CAA Environmental Statement

Permanent Airspace Change Proposals

Title of airspace change proposal	Aberdeen International Airport
Change sponsor	Aberdeen International Airport Ltd (EGPD)
Project reference	ACP-2019-082
Account Manager	[REDACTED]
<i>Instructions</i> In providing a response for each question, please ensure that the 'status' column is completed using the following options: • YES • NO • PARTIALLY • N/A To aid the SARG Lead it may be useful that each question is also highlighted accordingly to illustrate what is: resolved YES not resolved PARTIALLY not compliant NO

Figure 1 (left): Option 1 vectors (in yellow) to final approach (red) at Runway 16

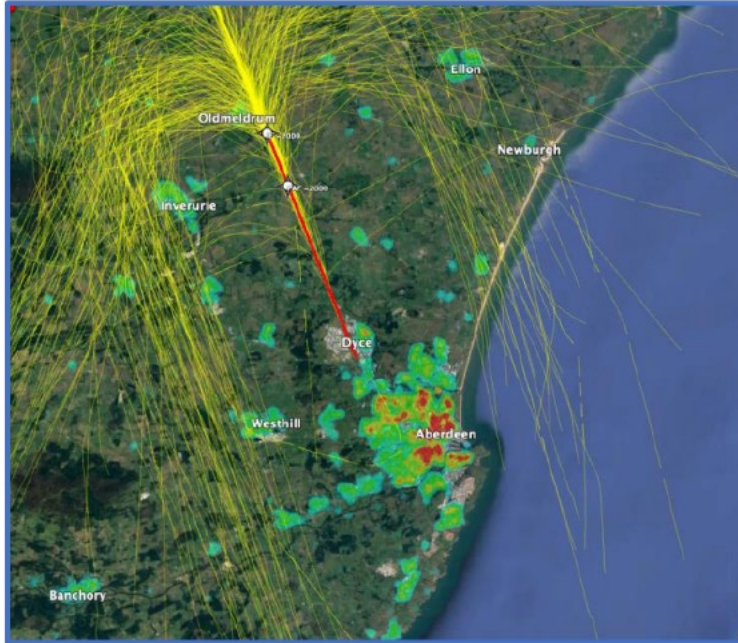
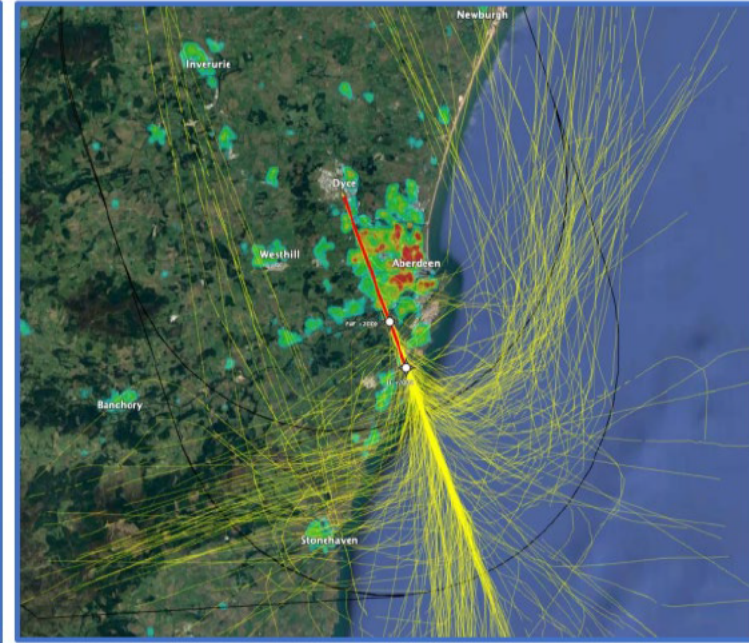
5. Final Airspace Design		Yes/No
5.1	Has the change sponsor described the final airspace design at year 1 and year 10 by taking into account any additional growth facilitated by the airspace change? (CAP 1616f paragraph 3.18)	Yes
	The final airspace design taken forward was Option 1: vectors to final approach to both Runway 16 and Runway 34. The proposed RNP arrival procedures are intended to be operated alongside the existing ILS approaches at Aberdeen Airport and are required to provide resilience for ILS outages and for training purposes. Evidence, based on historical data, has been provided indicating that there has been one unplanned ILS outage (duration 6 hours) in the past 5 years in addition to planned maintenance where the ILS has been taken out of service for approximately 5 hours per month and up to 14 hours on a 6 monthly basis. It is noted that routine maintenance mostly occurs during the night or when traffic volumes are low. This supports the sponsor's rationale that usage of the proposed RNP arrival

procedures will be limited to 1 – 5% of arrivals and that 95% of arrivals will continue to be vectored to the ILS as is currently the case. Aberdeen Airport supports a significant number of helicopter movements. Feedback from helicopter operators, indicates that the proposed RNP arrival procedures would only be used for training purposes and therefore the sponsor has estimated that up to 5% of helicopter flights are likely to use the proposed RNP arrival procedures. The ACP submission explains that arrivals using the RNP arrival procedures would continue to be vectored before final approach, but whereas with the ILS the arrivals have flexibility in where they join final approach from 15km (8nm) and beyond, the RNP arrivals would be vectored to join the final approach at a satellite-based waypoint. To minimise changes to tracks over the ground, the waypoints on the RNP arrivals design options have been positioned within the swathes of the existing vectored arrivals. The sponsor acknowledges that the procedures may result in a ‘small amount’ of concentration around the waypoint which could generate a marginal change in noise impacts however, this impact has been assessed as ‘negligible’. In addition, the proposed RNP arrival procedures are not expected to result in an increase in holding or in the number of missed approaches flown. The RNP MAPs replicate the existing ILS MAPs and, if required, would fly a hold predicated on the existing conventional ground beacon (ADN VOR). The sponsor provided the following operational diagrams using a 1-week sample of Aberdeen Airport’s existing arrivals (shown in yellow). For this option, aircraft would be vectored to join the RNP arrival procedures. The Initial Fix (IF) was positioned so that arrivals would join final approach at approximately 8nm, with the intention of keeping the vectored arrivals within the existing arrival traffic swathes.
